Date: 28 Nov 90
From: Kurt Chan, X3T9.2 Principal, Hewlett-Packard
To: X3T9.2 Membership
Subject: P-cable retention

X3T9.2/90-187

Thumbscrew-style P-connectors can be implemented quickly:

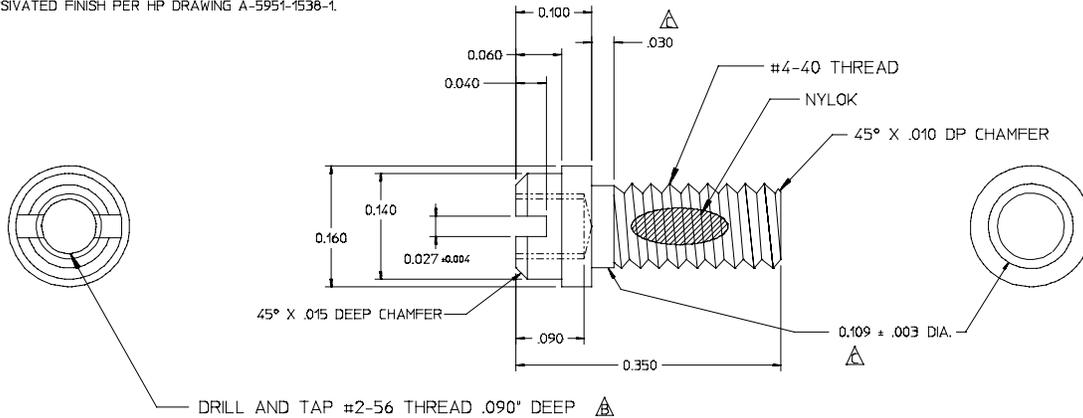
- Existing 68-pin SCSI device connectors can be used which have mounting holes tapped for 4-40 threads (instead of 2-56; these should be standard parts from some manufacturers soon if not already).
- Existing IPI screwlocks can be used to mount the device connectors to bulkheads (e.g., AMP749087-1).
- On the cable side, 68-pin thumbscrew molded cable assemblies can be manufactured independent of efforts by connector manufacturers to tool a 68-pin IPI can.
